REPLACING PAGE ADDENDUM

**BLOCK RELAY FRAME AND LINE DISTRIBUTING FRAME
CROSS-CONNECTIONS
NO. 1 CROSSBAR OFFICES**

1.001 This addendum supplements Section 216-719-301, Issue 4. The attached pages must be inserted in the section in accordance with the filing instructions above.

1.002 This addendum is issued to include cross-connecting information for offices provided with direct-in-dialing (DID) trunks to a 101 ESS PBX.

Fig. 2a—Sample Cross-Connection Fields of Block Relay Frame

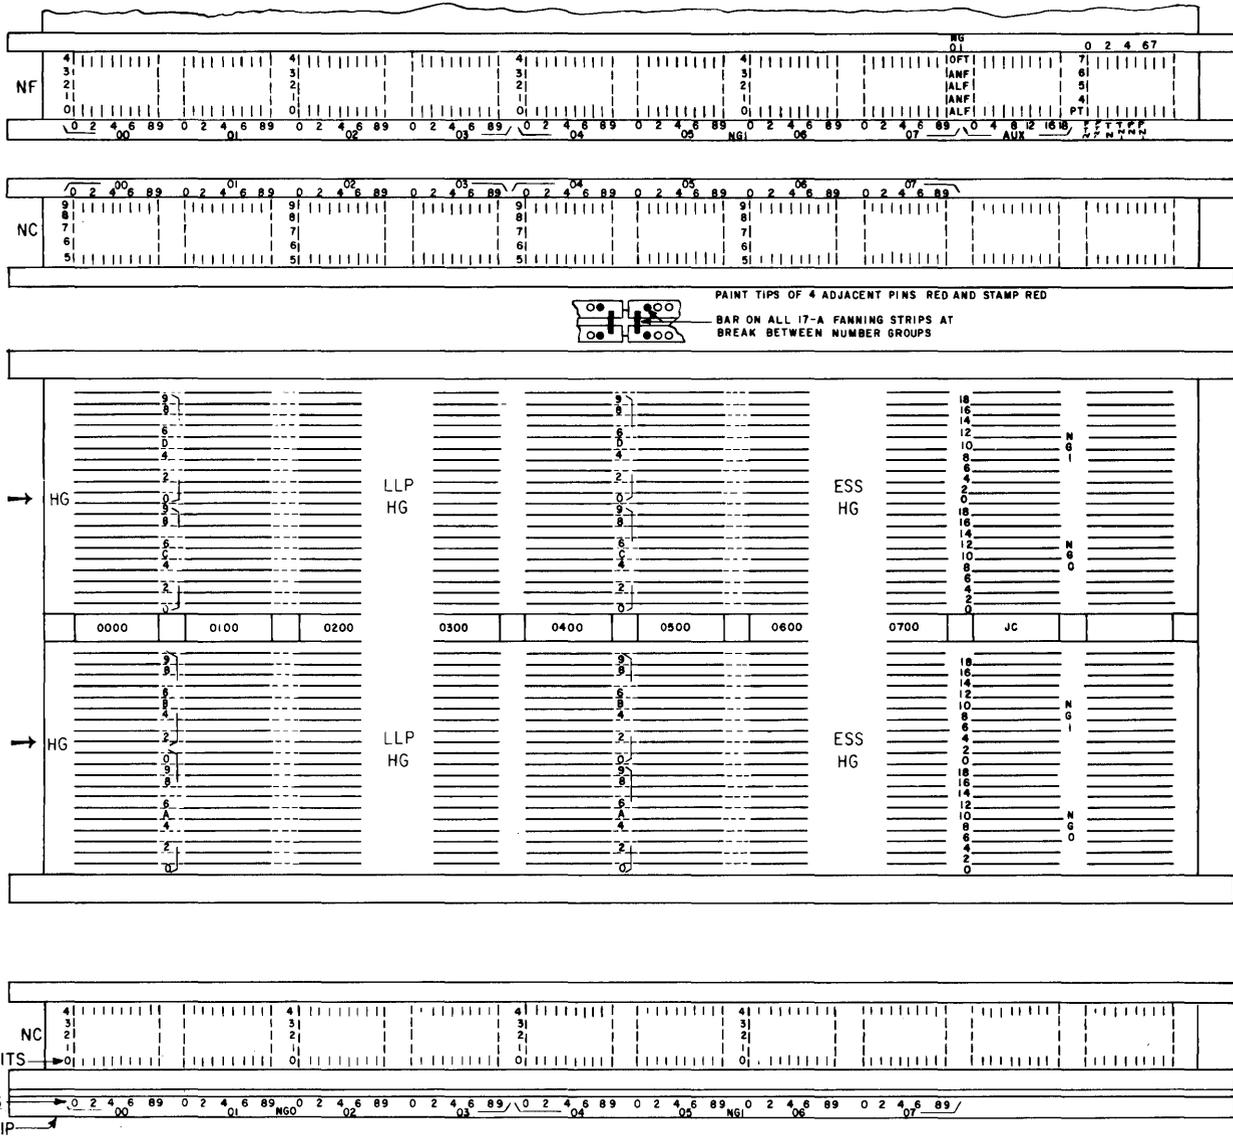
- (a) Paragraph 3.18.1 added to describe method of placing cross-connections required for DID trunks to 101 ESS PBX.
- (b) Paragraph 3.19 is revised to include NF cross-connections required for DID trunks to 101 ESS PBX.
- (c) Fig. 2A and 6 are revised to include ESSHG cross-connection field.

2.19 LLPHG, ESSHG Punchings: The LLPHG and ESSHG punchings are located adjacent to the HG punchings, as shown in Fig. 2a and 6. They are used, if provided, to inform the marker of the location of the LLP line circuit or 101 ESS trunk in the line choice. The LLPHG and ESSHG punchings are isolated from the HG punchings mentioned in 2.10 by a diode arrangement, but they have the same numerical significance. For example, cross-connection of an NC terminal to LLPHG A7 serves to inform the marker that the LLP line circuit is located in horizontal group 7 of line link frame A of the line choice.
